INDESIT company

Model type:
WIL85XSEX

Commercial code:
F030530

n1040319: Elimination of metal bar on INDESIT cabinets.

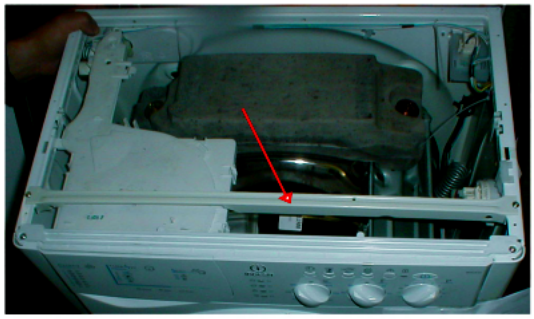
From serial no. 40223.0001 Indesit EVOII Washing Machines produced in the Comunanza - Brembate factory have been equipped with a wooden reinforcing strip on the top, whereas the metal bar on the cabinet has been eliminated.

The modified tops have the same Service code as premodification items (096937, 097617, 098440, 099929 and 097806).
When using the new top on a premodification appliance the metal bar (see N1040319FIG1) must be removed, whereas the old top can be used in place of the new one without any modification.
The new top can be used in place of the old one and vice versa; the Service code remains the same.

n1040325: New shock absorber fixing system with pin

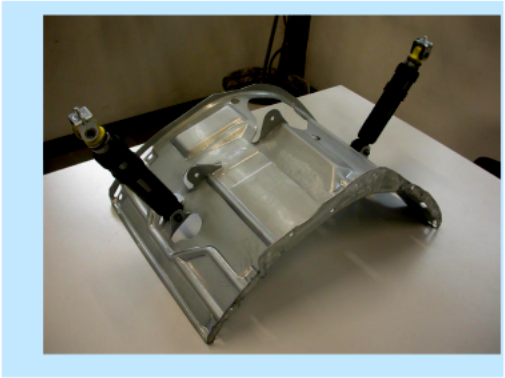
From serial no. 40427.0001, shock absorbers have been fixed to the tank unit cradle with two 11 mm pins code C00110163 (see fig. 01 and 02 enclosed) in place of the 8 mm screws code 093750 and relevant locking nuts code 030443, on all washing machines and dryers produced in the Comunanza factory.
The items affected by this modification are:
1) The cradles have the same Service code, as they can be used in place of the new ones after widening the shock absorber fixing holes to a diameter of 10 mm.
Code 093848 - Tank unit cradle 46 lt
Code 093878 - Tank unit cradle 40 lt.

2) The new shock absorbers, with fixing bushing having no s/steel spacer, are not managed as they are interchangeable with the premodified items (make sure they are CIMA type, as the managed items), fixed with M8 screws code 093750 and related locking nut code 030443 (see figs. 05 and 06).
Code 093884 - Shock absorber 80 N
Code 093885 - Shock absorber 100 N

To remove the shock absorber from the tank, first extract the pin with a few hammer taps (see fig.03) until it is aligned with the tank bracket and then pull it out with a pair of pliers (see fig. 04).
(To refit the shock absorber use a new pin. Insert the pin until the toroidal edge is aligned with the bracket.)

n1040376: Drain pump with filter with pin.

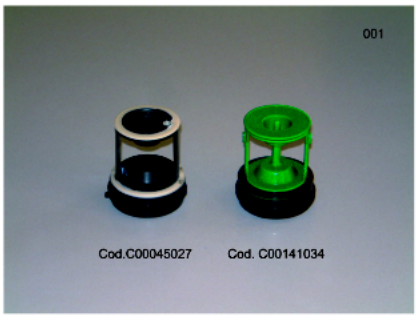
A new drain pump with filter with pin has been introduced progressively as from serial no. 50609.0001.

New parts:
C00119307 - Drain pump with pin filter;
C00141034 - Askoll / Plaset drain pump with pin filter kit (figure 001);

Premodification parts:
C00092264 - Drain pump;
C00045027 - Askoll / Plaset pump filter kit (figure 001);

The new parts can be used on all WASHING MACHINES previously equipped with the premodification parts.
